NUMBER D2-14934-6

TITLE WS-133A Maintainability Program, Final Report

MODEL NO. WS-133A CONTRACT NO. AF04(647)-289

ATTACHMENT A

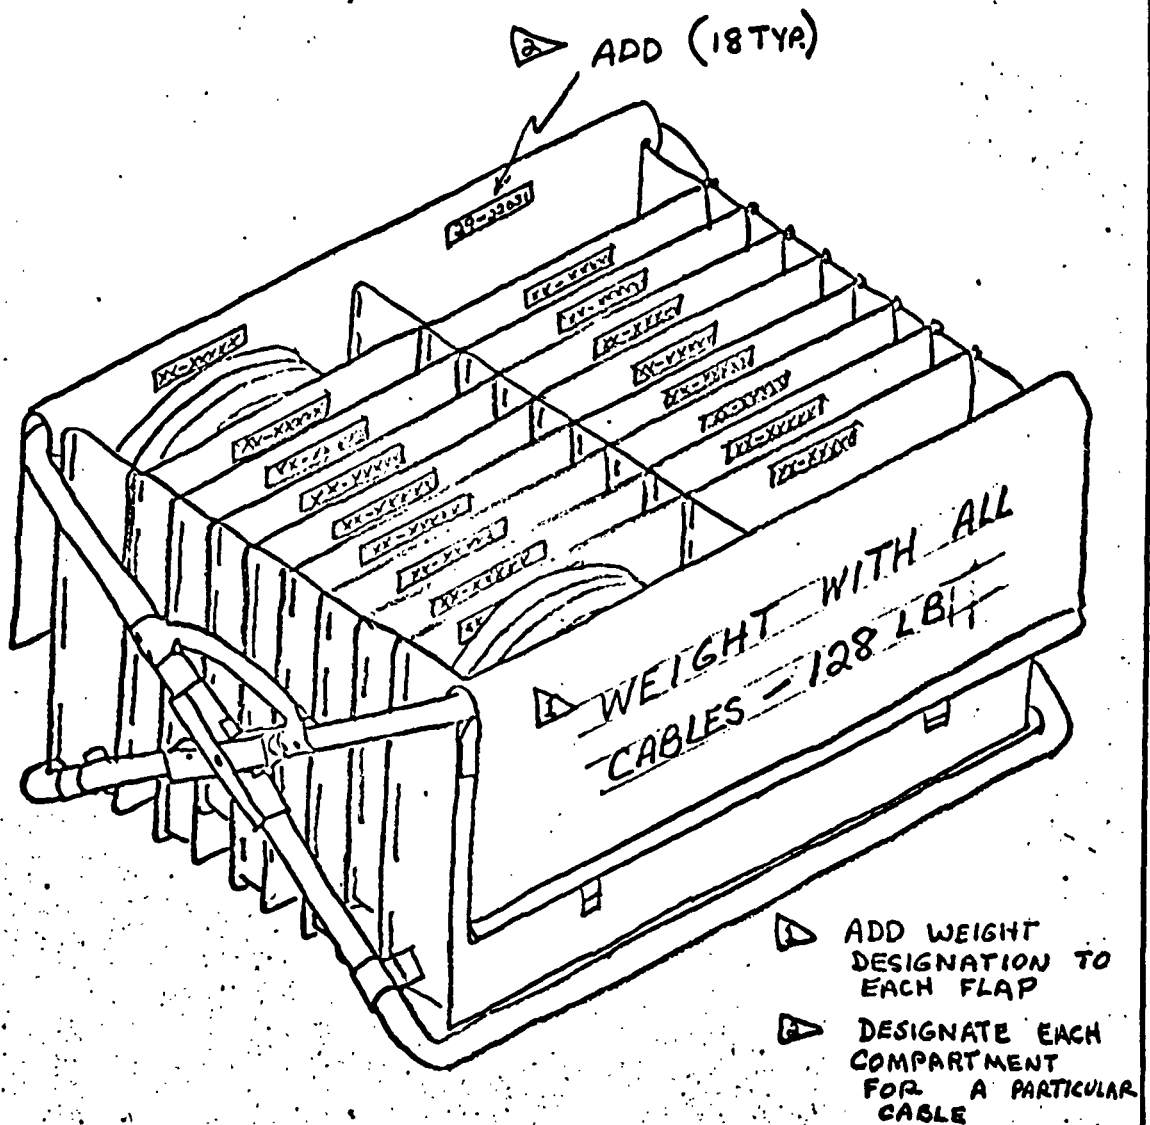
ELECTRICAL CABLE CASE
25-29147

ATTACHMENT B

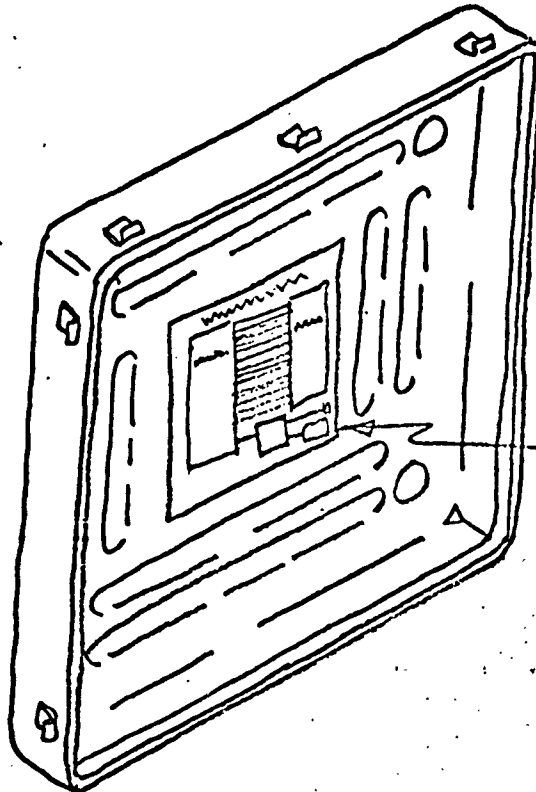
ADD
PLACARD SHOWING
CABLE HOOK-UP
FOR PROGRAMMER
GROUP TEST
SET SELF-TEST
(REF. T.O. 21-SM80A-23)
FIG. 2-25

Item 15

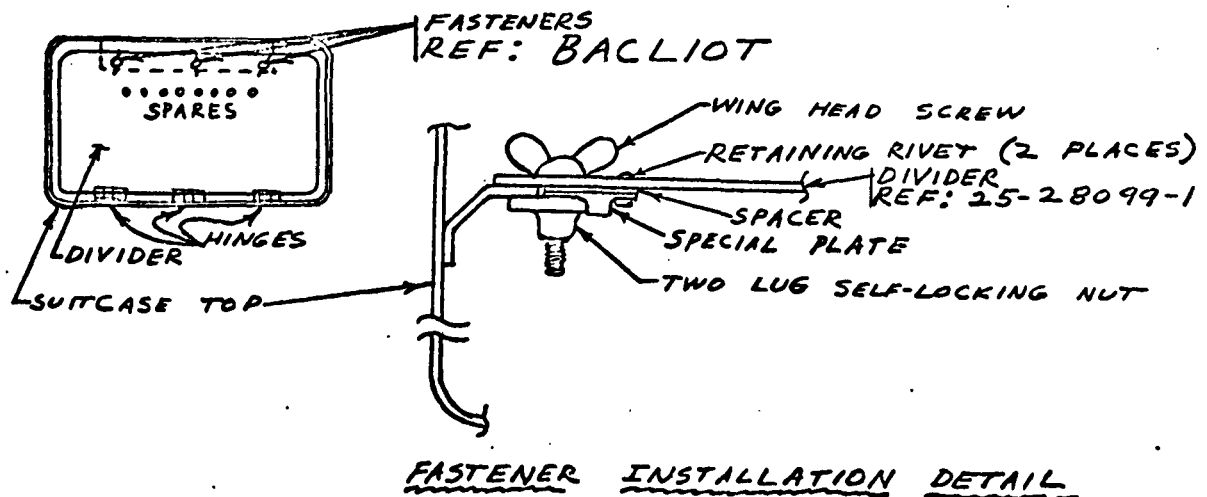
Problem: The Launcher Simulator and other Minuteman suitcases have a hinged divider in the cover opposite the hinge, three fasteners, BACLIOT, are used. These fasteners are difficult to engage under the cover lip as the two lug self-locking nut loses its locking feature and does not rotate under the lip when the wing head screw is tightened. After tightening the wing head screw the lug nut is not under the lip. When the cover is placed on the suitcase base the cover divider swings down and breaks the spare bulbs or fuse holders mounted on the divider. This fastener problem will continue to damage equipment, reduce spares, waste manhours, and reduce the operability of the equipment. See sketch below for fastener installation details:

Recommendation: Make the BACL10T type fastener inactive for Boeing design and monitor all subcontractors to assure that this type fastener is not used. In lieu of the BACL10T type fastener select a quarter turn quick release winged head fastener.
